IMPRESS FASHION LTD.

27 August 2015

Observations

Observations On DEA report of WASO Engineers & consultants (BD).

Inconsistency of drawings

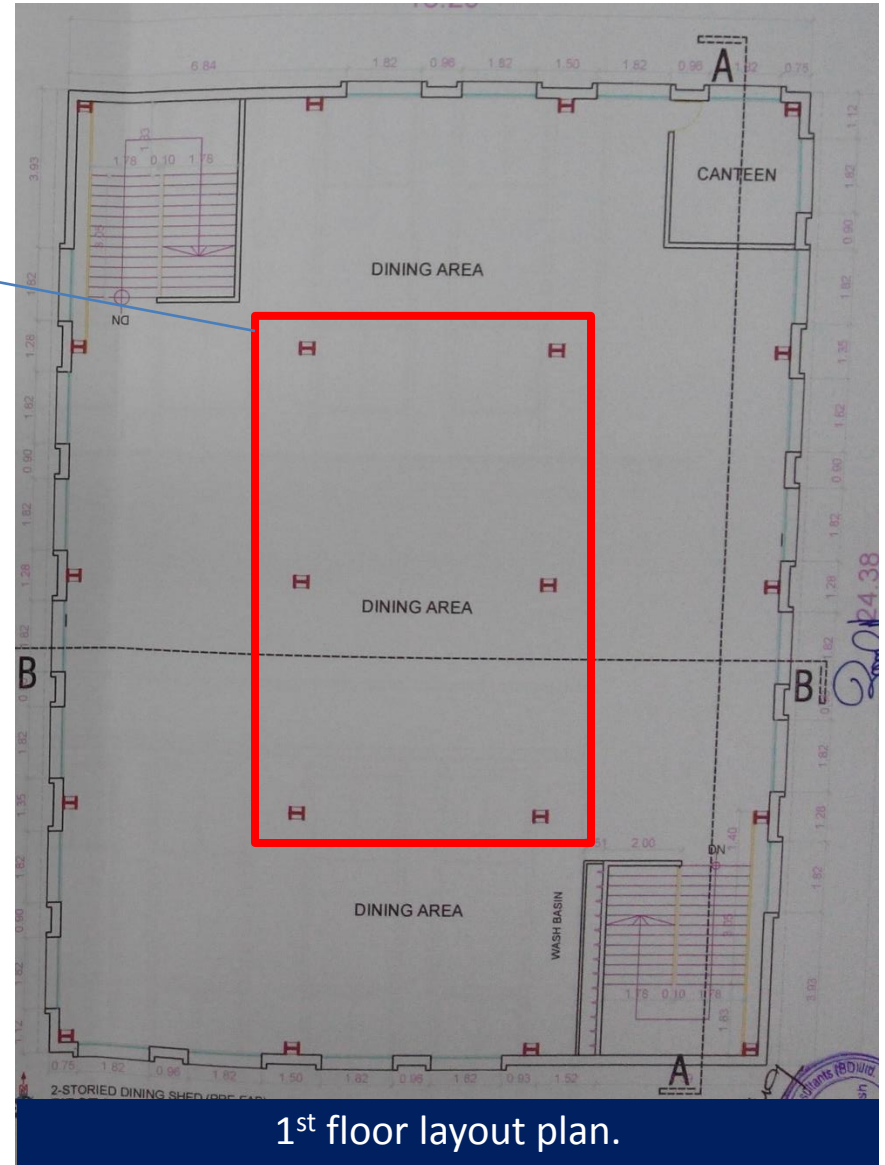
Indicated columns do not exist in the 1st floor.

- Building Engineer to update As built drawings

Steel corner Column

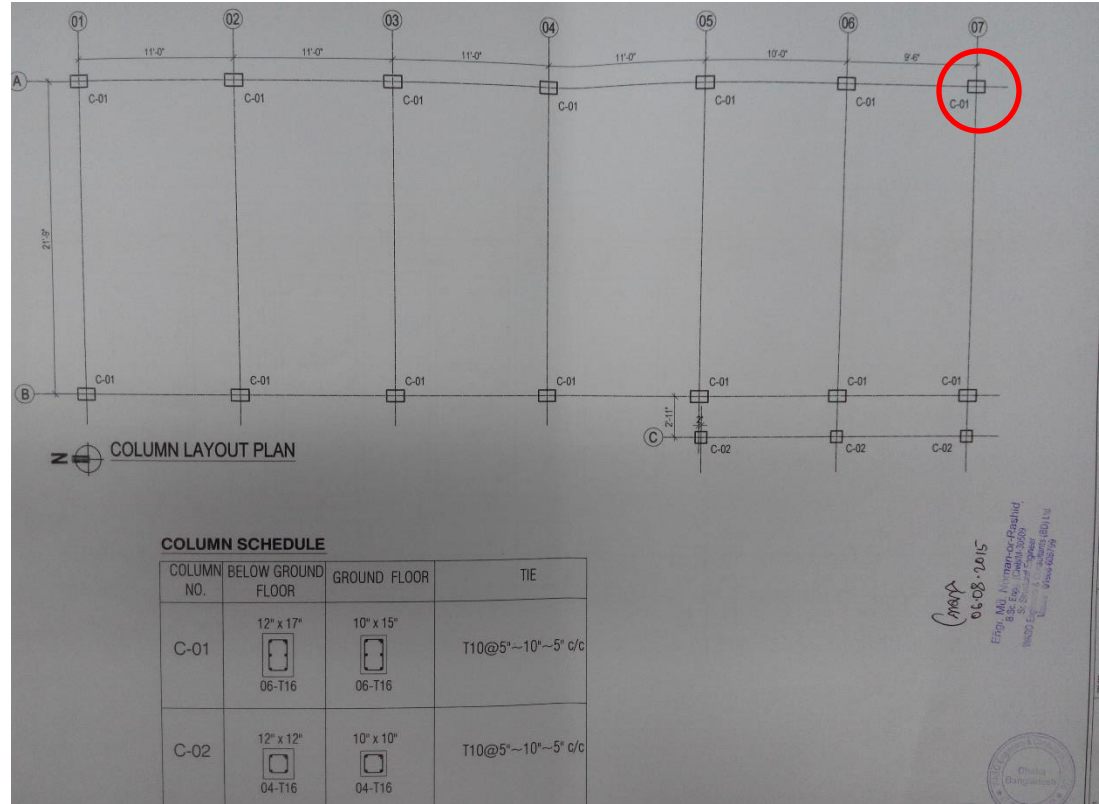
A Steel column found instead of Reinforced concrete column

Steel corner column was observed instead of Reinforced Column

- Define the load path and check the connection details.
- Check the adequacy of that column.

- Carry out recommendations suggested by the engineer.

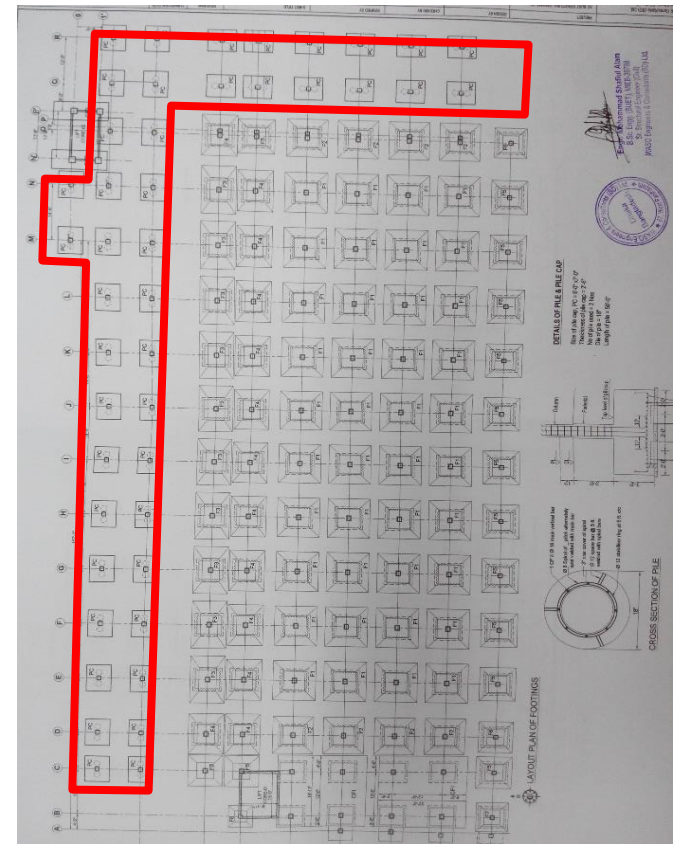
**Pile Foundations was stated to be okay
considering FOS 1.5.**

As mentioned in executive summary the structure is completed on 2013. From DEA report it was found the pile foundations were not ok with FOS of 2.5. But it was found ok if FOS is considered as 1.5. As per accord standard an existing factory that has performed for at least five years without indicating excessive settling, the factor of safety for pile foundation shall be at least 1.5.

Test points

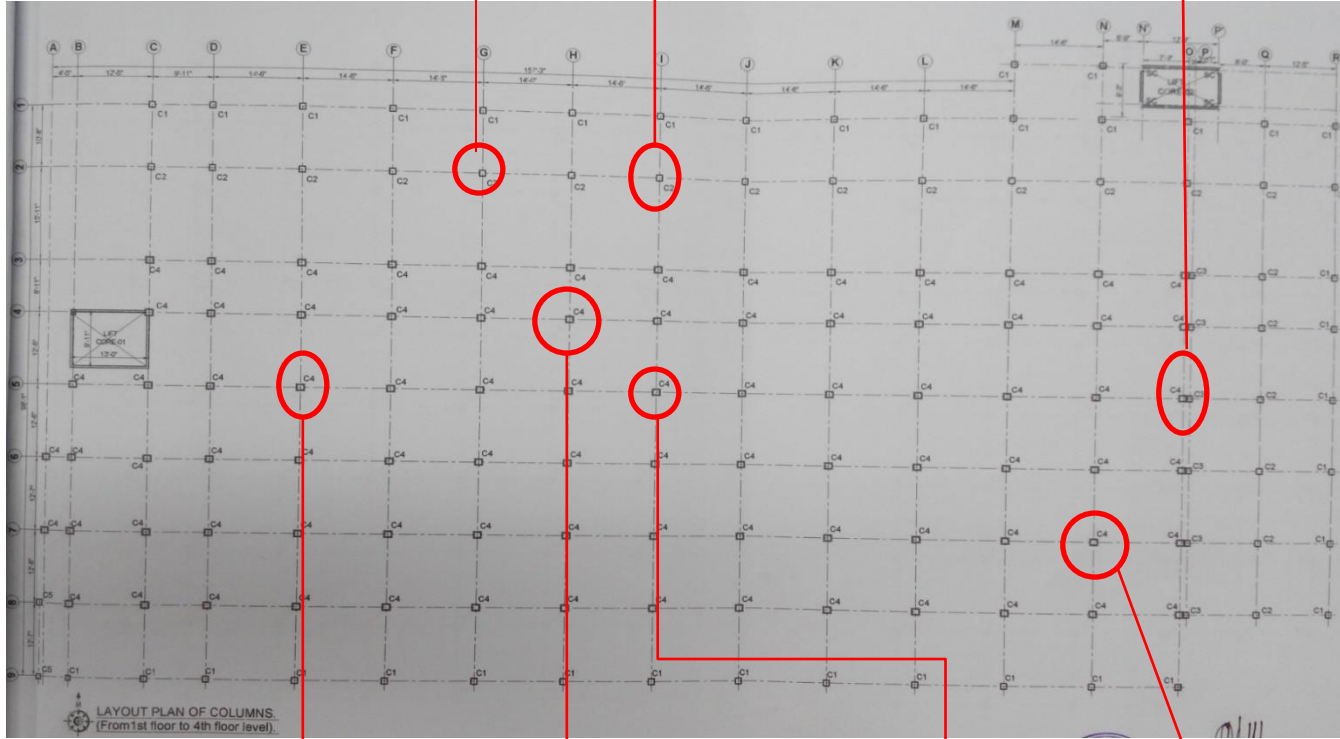
Average crushing strength from core test report was considered as Concrete strength for analysis.

Several cores have been taken from columns to determine the concrete strength. And they have considered 3000psi for retrofitted portion and 2500 psi for rest which is average of crushing strength.

Brick aggregate in GF

Brick aggregate in 4th Floor

Brick aggregate in GF with no gap between the columns

Stone aggregate was found on the Ground floor (retrofitted columns)

Brick aggregate in 5th Floor

Brick aggregate in 4th Floor

- Maintain 1 kPa load on this area (page 4) of all floors.
- Area shown on page 4 of 7th floor and roof cannot be used and cordon the construction work of toilet block before the revision of the detailed engineering assessment and maintain 1Kpa load on other floors.
- Verify insitu concrete stresses by considering existing core data and evaluate concrete strength using ACI code 562.
- Revise Detailed engineering assessment.

Test Point (Rebar Scanning)

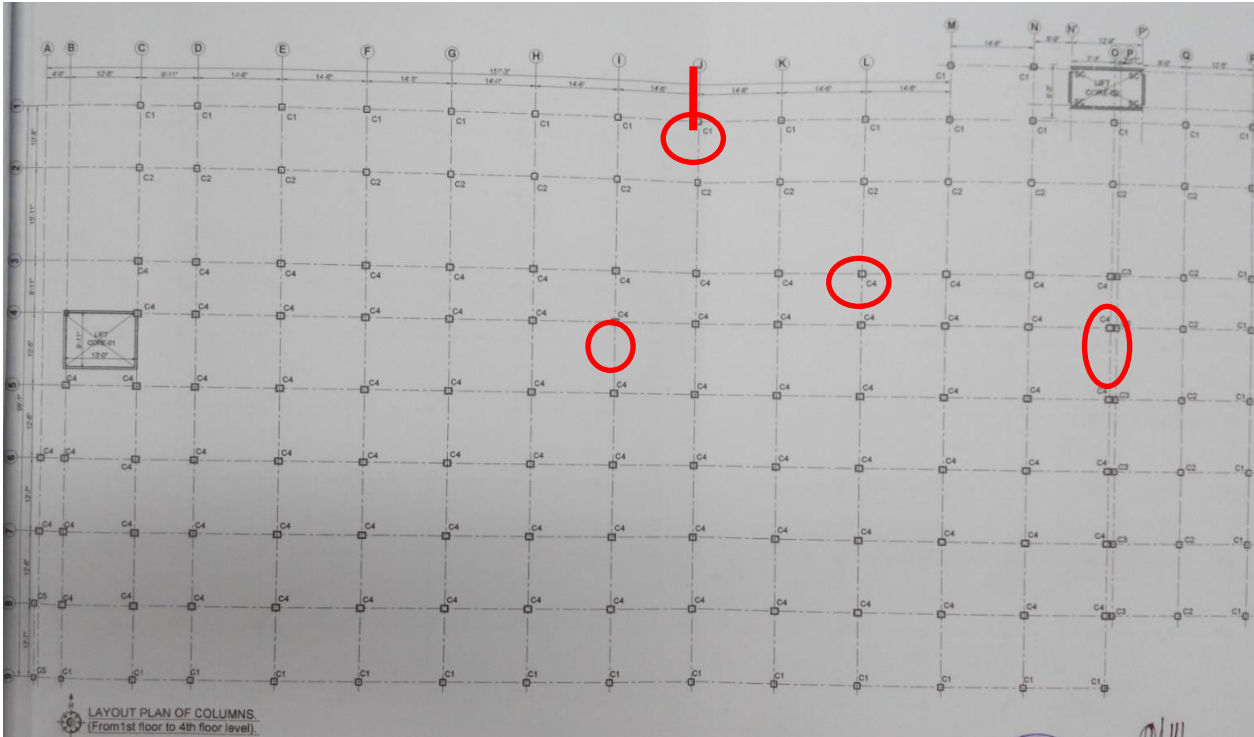
Indicated points at different floors were scanned. No mismatch was found with the provided drawing.
